SMO UKI, RAIL INFRASTRUCTURE, NEW CHIPPENHAM FACILITY: TOWN AND COUNTRY PLANNING ACT 1990 (AS AMENDED), SECTION 96A – APPLICATION FOR NON-MATERIAL AMENDMENTS PURSUANT TO PLANNING PERMISSION REF: PL/2024/03204

On behalf of Siemens Mobility Limited (*“the Applicant”*), please find enclosed an application (*“the Application”*) for non-material amendments to planning permission Ref: PL/2024/03204 granted by Wiltshire Council on 25 October 2024, as amended by non-material amendment application Ref: PL/2025/01624.

Figure 3: Indicative 3D Visuals (Longer Views) - Left: South-East Elevation as approved / Right: South-East Elevation as proposed

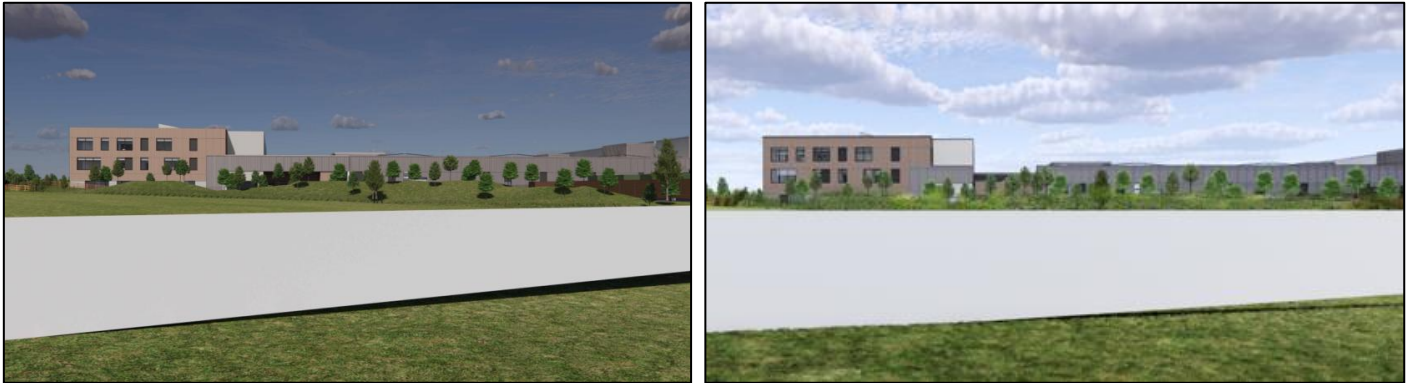
As can be seen in **Figure 3**, the proposed cladding omission reduces the overall sense of scale and massing of this part of the building, whilst upholding the original design intent, with the high-level cladding continuing on either side of the terrace, maintaining the architectural link between the building's functions. Further, removing the roof section will enhance the sense of openness and create a lighter and more welcoming approach to the entrance of the building.

Figure 4: Extract from Left: Approved Roof Plan (Ref: SMC-AHR-ZZ-00-D-A-008203 P06) and Right: Proposed Roof Plan (Ref: SMC-AHR-ZZ-00-D-A-008203 P06-B)

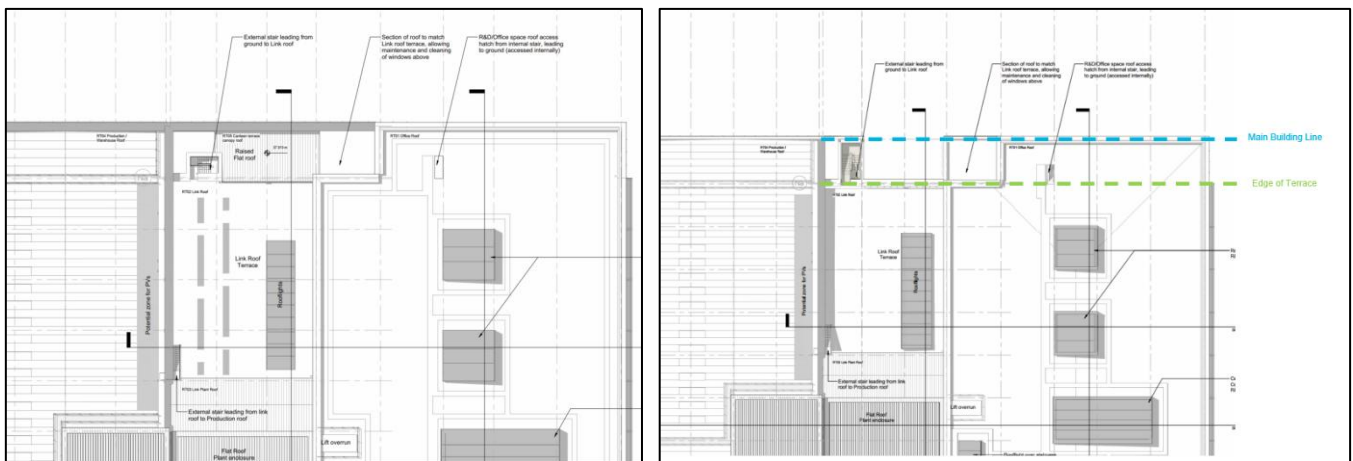
As shown in **Figure 4**, the roof level terrace remains set back from the main building line. It is proposed that the cladding that followed the main building and raised flat roof are removed and replaced by a 1.235m high parapet that is set back from the main building line and follows the line of the terrace instead.

Figure 5: Left: Soft Landscaping as Approved (Ref: SMC-AHR-EX-ZZ-D-L-008121 REV P07) / Right: Soft Landscaping as Proposed (Ref: SMC-AHR-EX-ZZ-D-L-008121 REV P07-B) (2 No. new trees identified in red)

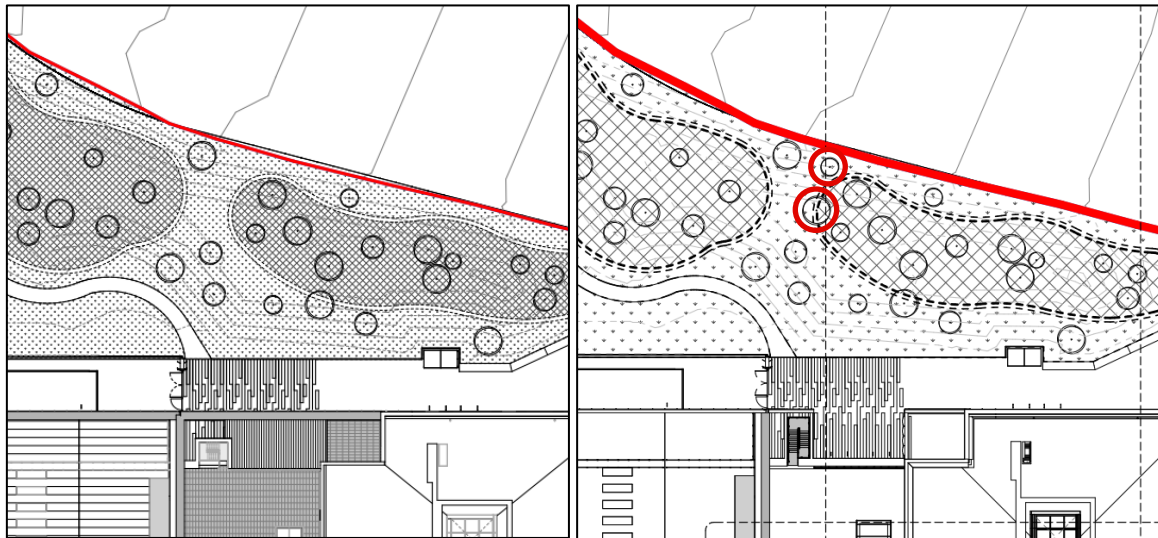
Notwithstanding, it is proposed to update the landscape buffer along the south-eastern boundary with two additional trees proposed atop the bund adjacent to the terrace area. See extracts from the approved (Ref: SMC-AHR-EX-ZZ-D-L-008121 REV P07) and proposed soft landscaping plans (Ref: SMC-AHR-EX-ZZ-D-L-008121 REV P07-B) in **Figure 5** below. The enhanced landscaping will strengthen the approved landscape buffer and further contribute to the biodiversity enhancement of the Site.
